UNITED STATES PATENT AND TRADEMARK OFFICE

APPLICATION NO.	FILING DATE	FIRST NAMED INVENTOR	ATTORNEY DOCKET NO.	CONFIRMATION NO.
10/605,528	10/06/2003	Kazuhiro Takeda	SIC-03-036	2527
29863	7590	01/25/2006		
DELAND LAW OFFICE P.O. BOX 69 KLAMATH RIVER, CA 96050-0069			EXAMINER LEE, GUNYOUNG T	
			ART UNIT 2875	PAPER NUMBER

Office Action Summary	Application No.	Applicant(s)	
	10/605,528	TAKEDA, KAZUHIRO	
	Examiner	Art Unit	
	Gunyoung T. Lee	2875

DETAILED ACTION

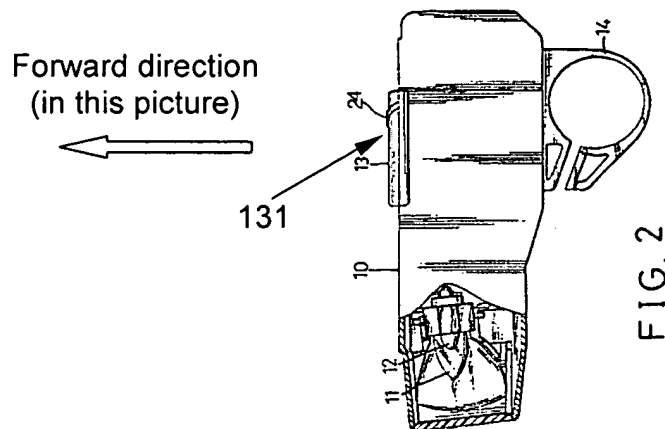
- A computer housing (Fig.1, 10) adapted to be mounted to a bicycle (32);
- A computer/microprocessor (Fig. 4, 20) housed within the computer housing (10);
- A display (Fig. 2, 13) housed within the computer housing (10), wherein the computer (Fig. 4, 20) controls information provided on the display (13);
- A lighting device (Fig. 3, 131) within the computer housing (10), wherein the lighting device (Fig. 4, 131) is controlled by the computer/microprocessor (20);

- Wherein a same lighting device (Fig. 4, 131) provides backlighting for the display (13) as well as lighting outside of the computer housing (10).
10. In regards to claim 6, Lin further discloses:
- Wherein the light emitted by the lighting device (Fig. 4, 131) is directed forwardly outside of the computer housing (as shown in the following picture).

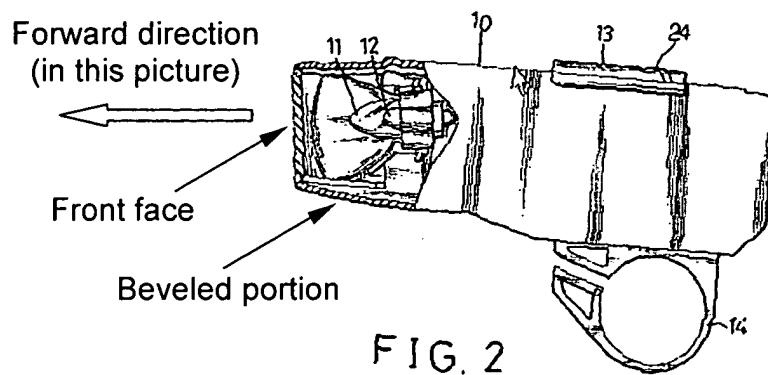
- Wherein the computer housing (Fig. 2, 10) includes a front surface that faces primarily forwardly and not downwardly (as shown in the picture on page 6);

- A display (Fig. 2, 13) housed within the computer housing (10) and inclined rearwardly;
- Wherein the beveled portion is beveled downwardly (as shown in the picture on page 6).

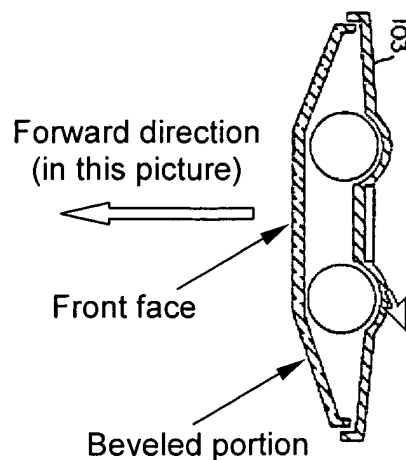
However, Lin does not disclose that the light emitted by a lighting device is directed through the beveled portion (claim 1). In regards to a beveled portion through which the emitted light by a lighting device passes, Lindh discloses a bicycle lamp device (Abstract, lines 7-10) having a transparent plastic cover (Fig. 1, 1) (col. 2, lines 57-58) having a front surface that faces primarily forwardly (as shown in the following picture) and a beveled portion through which the light emitted by a lighting device (Fig. 2, 2) passes inherently.
